Report on	Mid Ulster District Council's response to a consultation request from Fermanagh & Omagh District Council for planning application LA10/2020/0206/F for An energy storage facility consisting of 2 no. battery storage compounds, customer electrical substation compound, a grid electrical substation compound, rainwater harvesting area, site access track and other associated infrastructure, site to be surrounded by deer fencing, 5 no. CCTV locations and gates, South of Classic Marble ((Showers) Ltd, 31 Garvaghy Bridge Road, Garvaghy, Dungannon for Engie Developments Ireland Ltd
Date of Meeting	4 th August 2020
Reporting Officer	Phelim Marrion
Contact Officer	Dr Chris Boomer

1.0	Purpose of Report
1.1	To seek members agreement to respond to a consultation on a planning application that Fermanagh & Omagh District Council) are considering.

Approved scheme vs proposed scheme

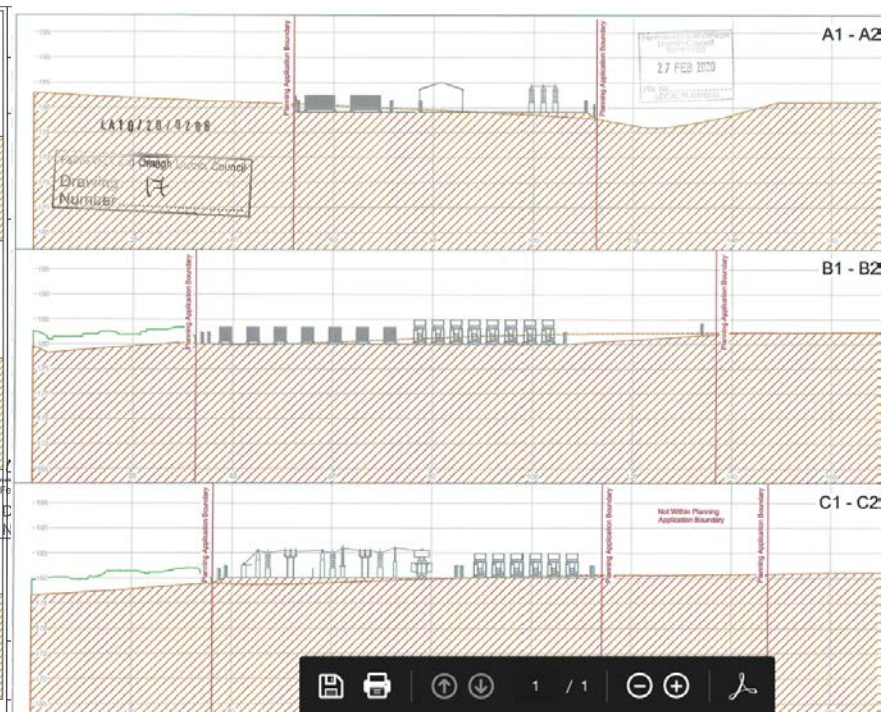
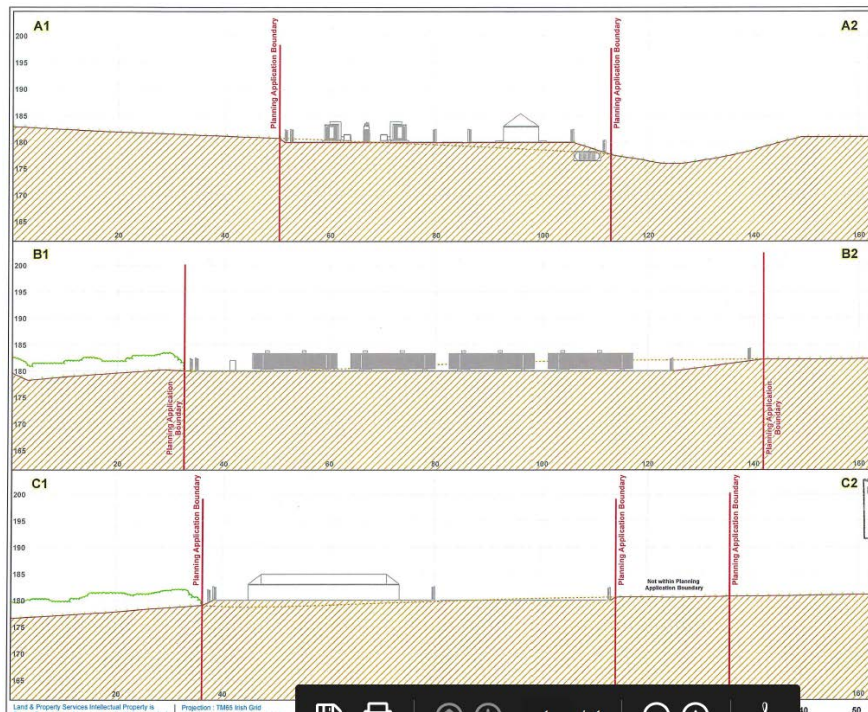
2.3	<p>The scheme that FODC has now consulted on is for 14 no. steel containers, 16.15m long x 2.82m wide x 3.30m in height with 4 no HVAC cooling units (2.30m long, 1.35m wide and 1.55m in height) on top of each, 16 inverter stations 6.48m long x 2.80m wide x 3.30m in height, 2 pitched roof sub station buildings, one for SONI which is 11.9m long x 8.9m wide x 6.0m and one for Engie which is 9.0m long x 8.8m wide x 6.0m high and a cesspool and rain water harvesting area all enclosed within a 2.3m high palisade fence and a 2,4m high mesh security fence. The site is also to have 5 security cameras mounted on 4m high poles</p> <p>The sub station and battery array will be used in conjunction with the approved and built 110kV OH power line which links Tamnamore to Omagh and has a large substation close by.</p>

3.3	The site is well integrated in the local landscape with views from the main road limited to close to the access position due to the landform. The site will also be viewed for a short distance from the Garvaghy Bridge Road to the east. It will be seen with the factory, the power lines and substation which gives the area quite an industrial appearance. I consider a landscaping scheme should be requested and implemented around the compound to help reduce the visual impact on what can be an open exposed landscape.

5.0	Recommendation(s)
5.1	<p>That members agree to the following response to be issued to OFDC Planning Department:</p> <ol style="list-style-type: none"> 1. Mid Ulster District Council have no concerns in relation to the access for the development and long term visual impacts of this development provided a robust and properly detailed traffic management plan and landscaping and maintenance proposals are agreed prior to commencement of development and properly condition for implementation.
